Subject: PC 23-003 - Orion Villas Site Plan Review #2

Re: Orion Villas
Site Plan Review #2
NFE Job No. N569

To: Planning Commission/Planning & Zoning Director
From: Jeff Williams, Fire Marshal
Re: Orion Villas Site Plan Review 2nd Submittal
Date: May 26, 2023

RE: Orion Villas
Site Plan Review #1

SCALE	1" = 10'
SHEET	3 OF 5
KE	2021.171

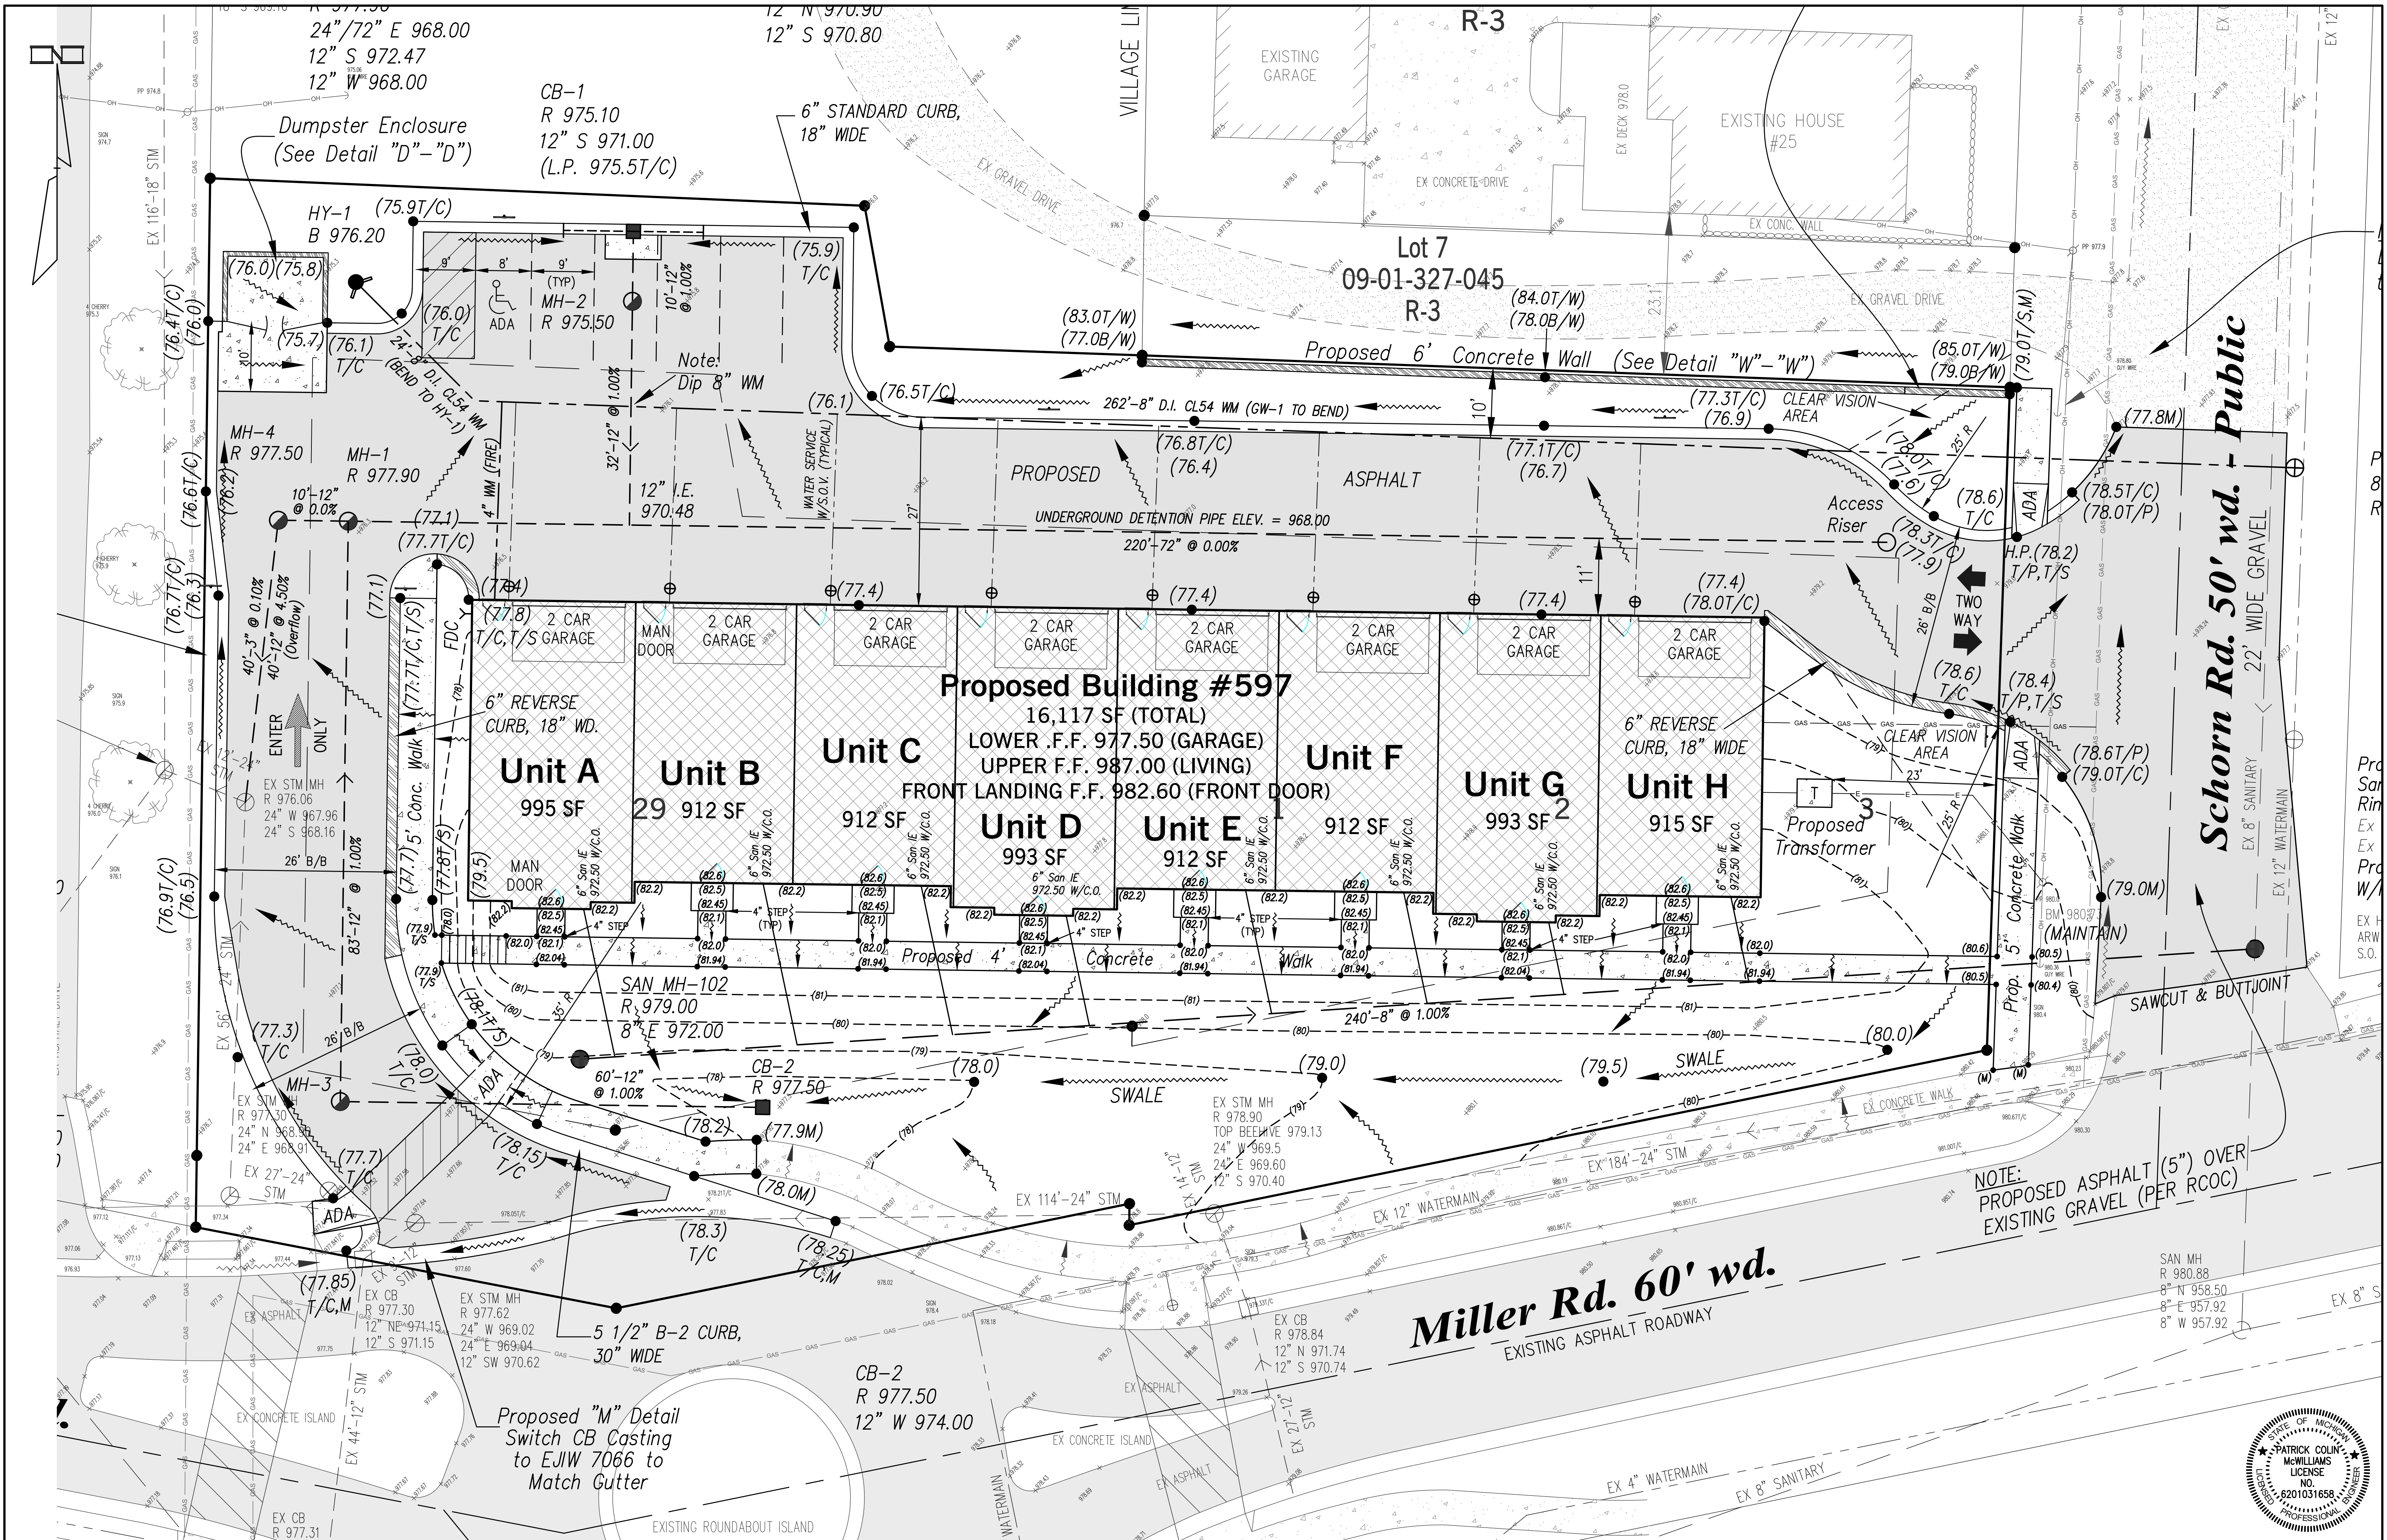
6. We note that the 10' dimension shown on sheets 3 and 4 along the NE property line appears to mark the distance from the property line to the proposed water main, meaning that the proposed 6' high concrete screen wall will be located closer than 10' to the water main and within the proposed water main easement. Additionally, landscape planting have been added along the face of the wall as well. Easement width and accessibility must meet the requirements of Orion Township.

Landscape
Planting
PlanIssues / Revisions
Revision per Twp Review 5/8/2023

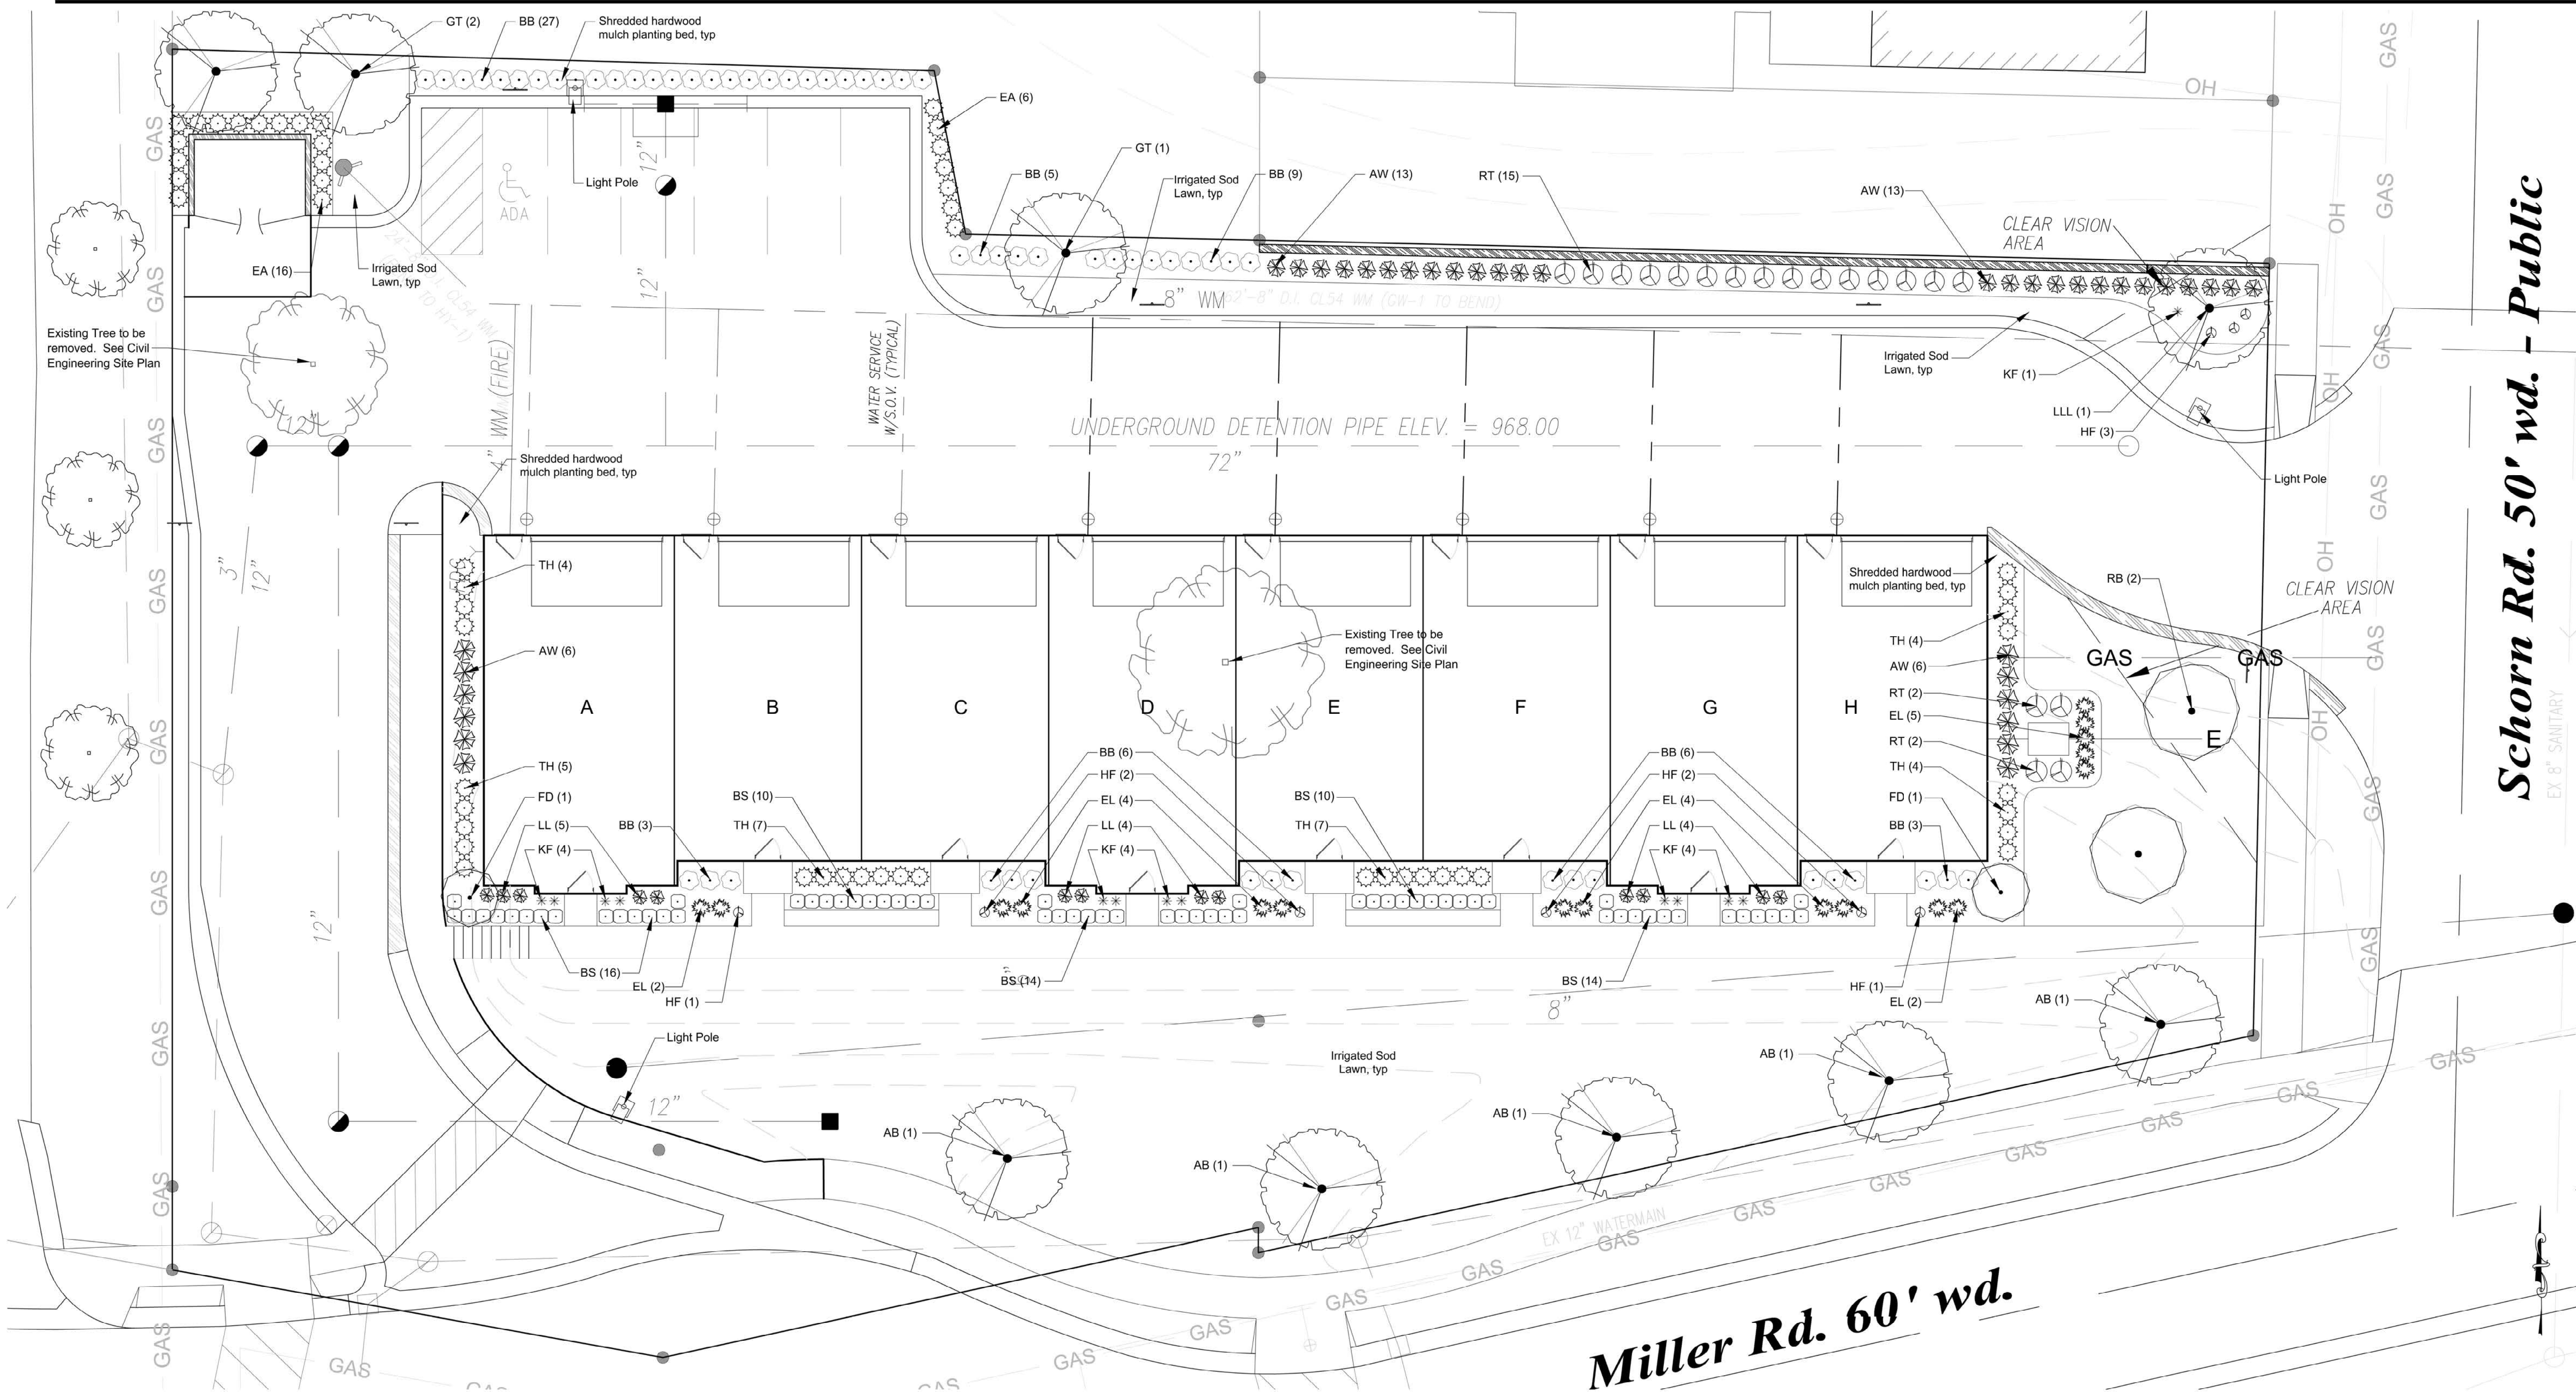
Per section 15.02, no single species shall consist of more than 20% of any particular type of plant material provided on a site, therefore, total plantings of a given type should be a multiple of five. The landscape plan on Sheet LP-1 notes several species comprising 20% or more of a given plant type. For instance, nine deciduous trees are proposed, with five as red maples. To reach the variety requirement, the applicant must propose an additional tree and limit each species to two on the site. We recommend increases to both the number and variety of tree plantings to meet this standard; however, the Planning Commission may waive this requirement if it finds the landscaping to be sufficient.
